Office Action Summary	Application No. 10/590,125	Applicant(s) SCHLIENGER ET AL.	
	Examiner STEVEN J. COTRONEO	Art Unit 3733

DETAILED ACTION

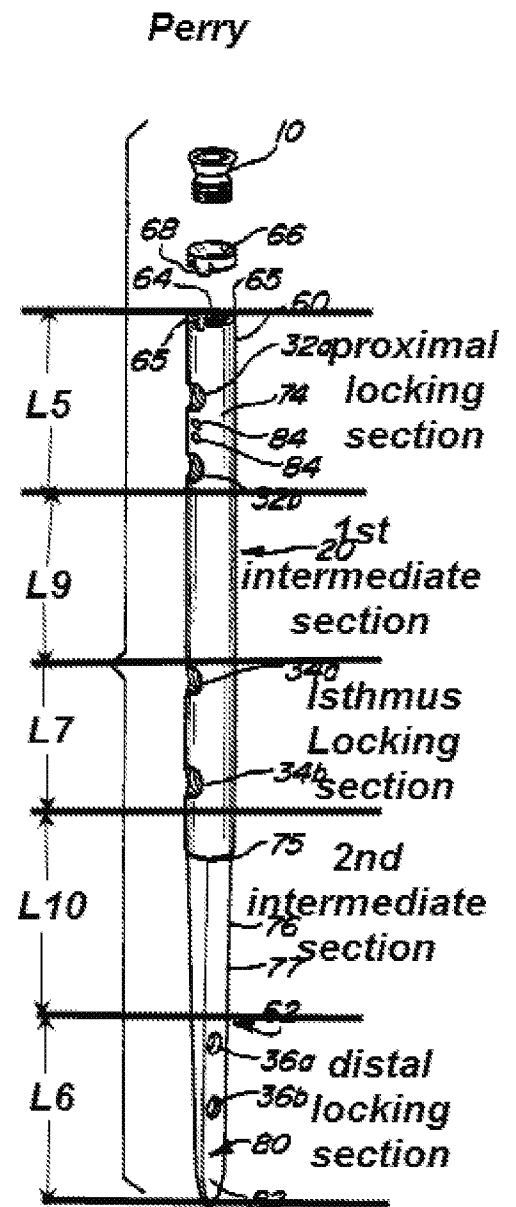
Perry discloses an intramedullary nail comprising: an elongated nail body having a proximal end, a distal end for insertion into the medullary canal, a central axis and a total length L; a proximal locking section (fig 4, 32), distal locking section (fig 4, 36), and isthmus locking section (fig 4,34) spaced along the length of the nail body, the proximal

locking section nearest the proximal end, the distal locking section nearest the distal end, and the isthmus locking section located between the proximal and distal locking sections, and each locking section including a through-hole for receiving a locking screw; a first intermediate section (see fig 4 below) separating the proximal and isthmus locking sections, and a second intermediate section (see fig 4 below) separating the isthmus and distal locking sections, each intermediate sections having fewer through-holes per unit length than the locking sections. The intermediate section has no through-holes (fig 1).

Perry does not disclose wherein the proximal locking section forms an angle B with the intermediate section, where B is in the range of $7^{\circ} < B < 13^{\circ}$ **and does not disclose the proximal locking section comprising an elongated through hole.**

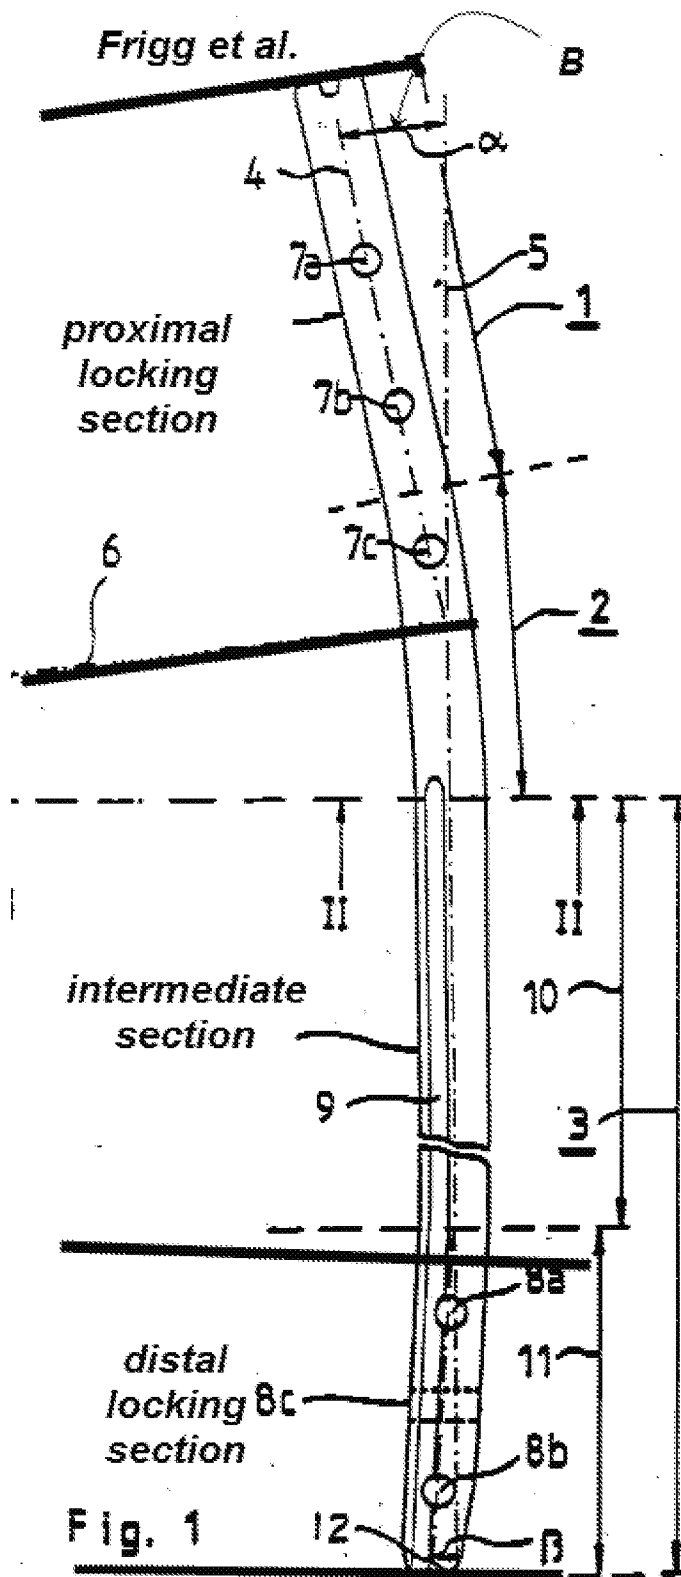
Frigg et al. a proximal locking section forms an angle B with the intermediate section (see fig 1 below), where B is in the range of $7^{\circ} < B < 13^{\circ}$ (col. 4 ll. 40-42, "8 to about 18 degrees") to allow for use in the tibia (abstract).

Fig. 1

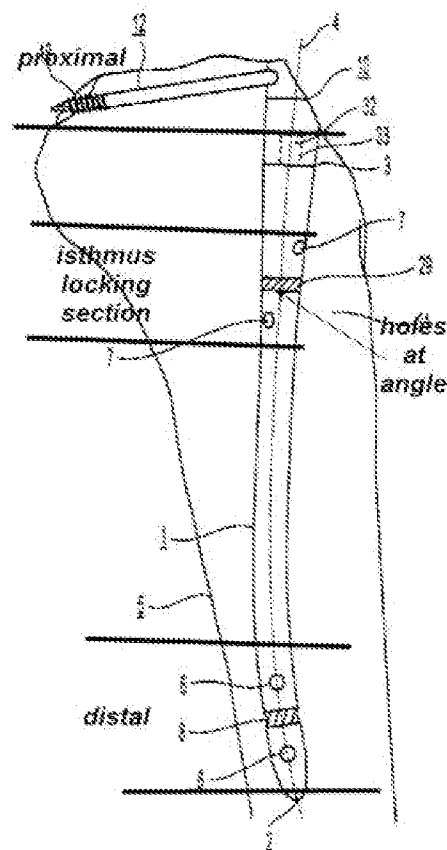
Leu et al. discloses the isthmus locking section includes two through holes arranged at a relative angle A (see fig 1 below) to allow accurate positioning of the intramedullary nail in the intramedullary space (col. 3, ll. 60-63).

Perry in view of Frigg et al. and in view of Buhren et al. in view of Leu et al. discloses the claimed invention except for the relative angle being 90 degrees. The angle between Leu et al. through holes 7 is not disclosed in the specification but appear to be around 90 degrees. It would have been obvious to one having ordinary skill in the art at the time the invention was made to have the relative angle being 90 degrees, since it has been held that discovering an optimum value of a result effective variable involves only routine skill in the art. In re Boesch, 617 F.2d 272, 205 USPQ 215 (CCPA 1980).
